**PUBLIC WORKS DEPARTMENT**  
ENGINEERING DIVISION  
156 S. BROADWAY, SUITE 150  
TURLOCK, CA 95380

**City Project No.:** 19-51

**Addendum No.:** 1

**PROJECT TITLE:** Columbia Pool Improvements

**GRADING &  
DRAINAGE PLAN**

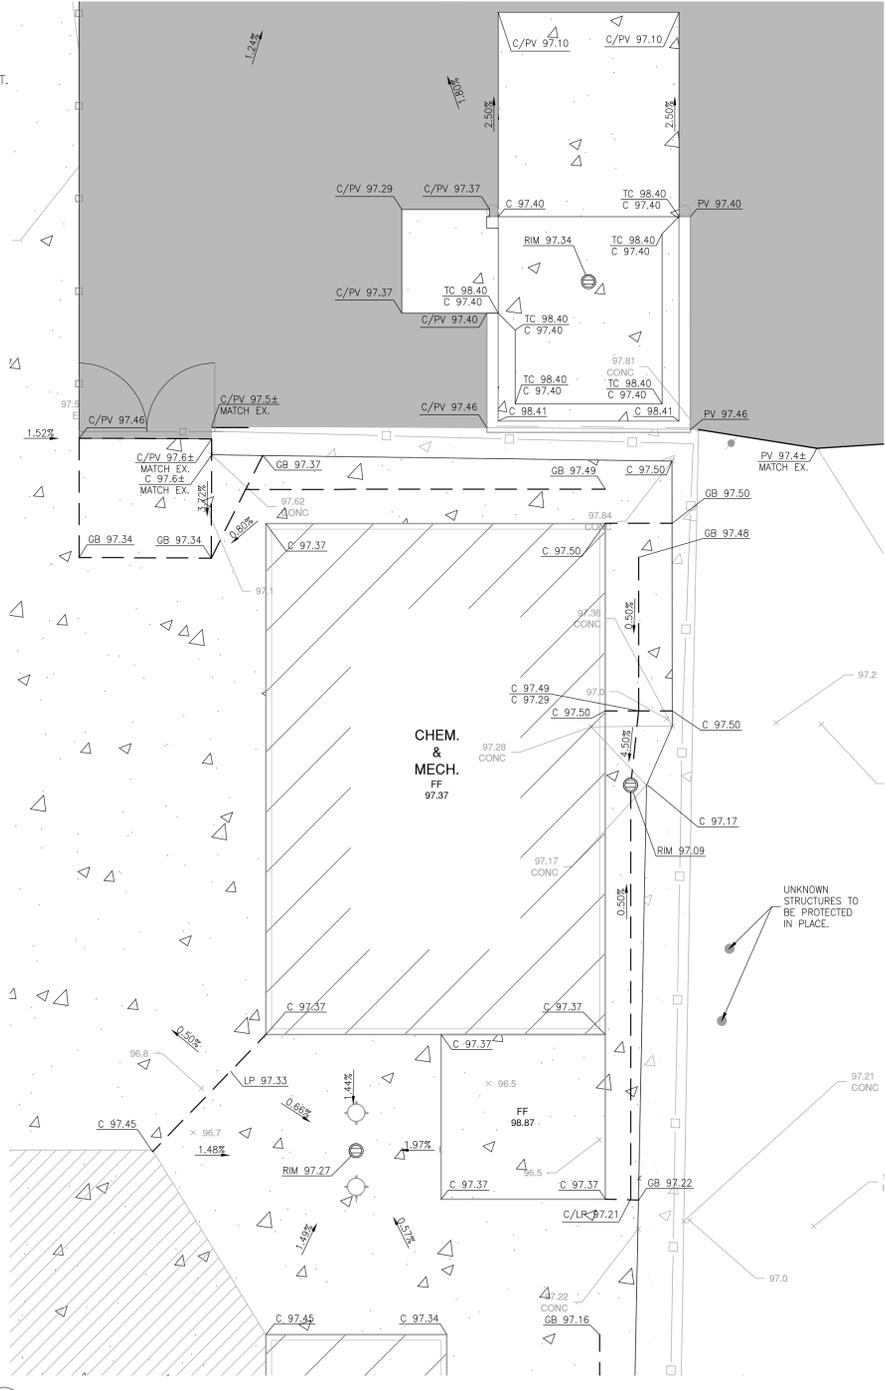
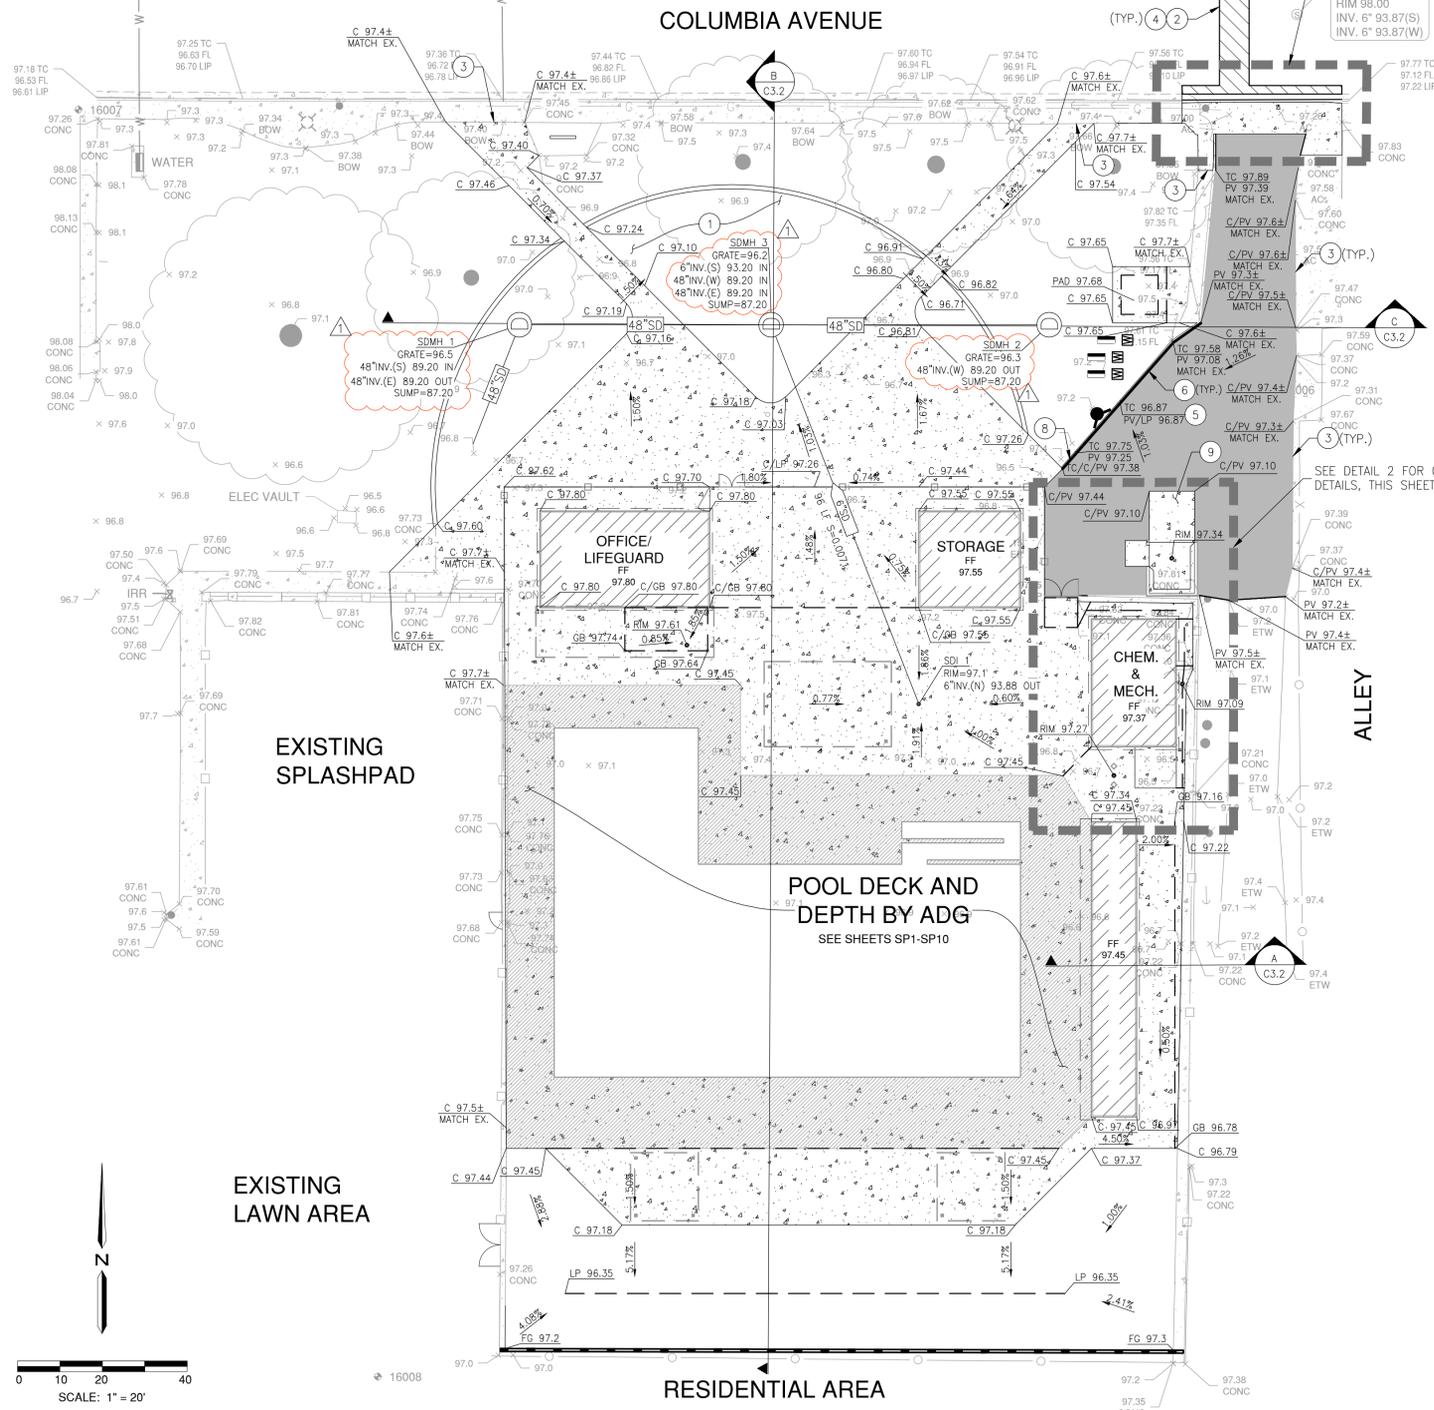
***6" Vertical Curb:***

***Alley Approach:***

Remove and replace sheets C2.0, C3.0, and C4.2 with the attached sheets.

**UTILITY PLAN**

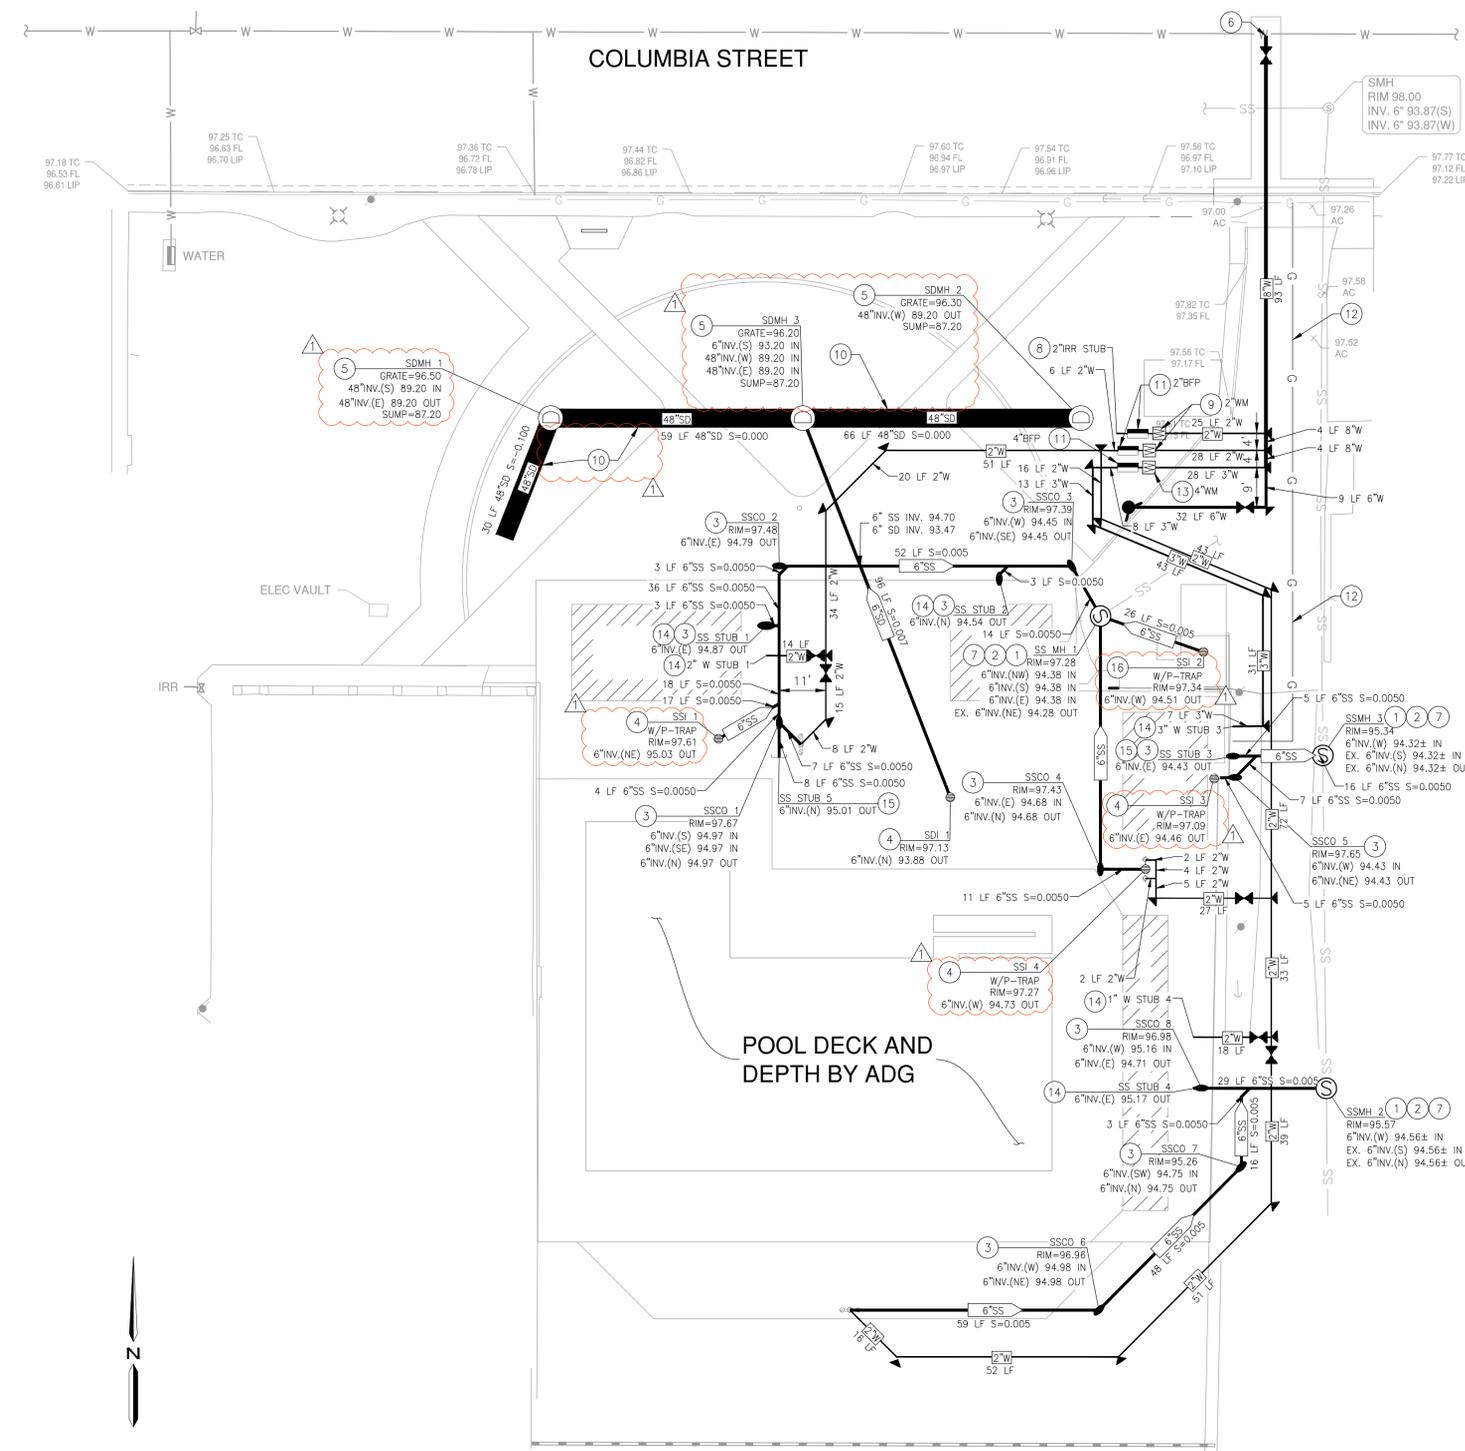
***Nyoplast Drain Basin***

***The unit price bid for this item shall include all costs for purchase and installation of the drain basin, frame, grate, and related components and connections to stormwater system, as indicated on the Drawings. The item also includes labor, materials and all other work required by the Drawings and Specifications which is not specifically set forth in the Bid Form as a pay item.***

- SANITARY SEWER CLEAN OUT AND COVER PER CITY OF TURLOCK STANDARD DETAIL S-7, SEE SHEET C4.1
- AREA DRAIN PER DETAIL 7, SEE SHEET C4.2.
- NYLOPLAST 24" DRAIN BASIN WITH FRAME & GRATE (H10 LOADING MIN.) OR APPROVED EQUAL PER DETAIL 5, SEE SHEET C4.2.
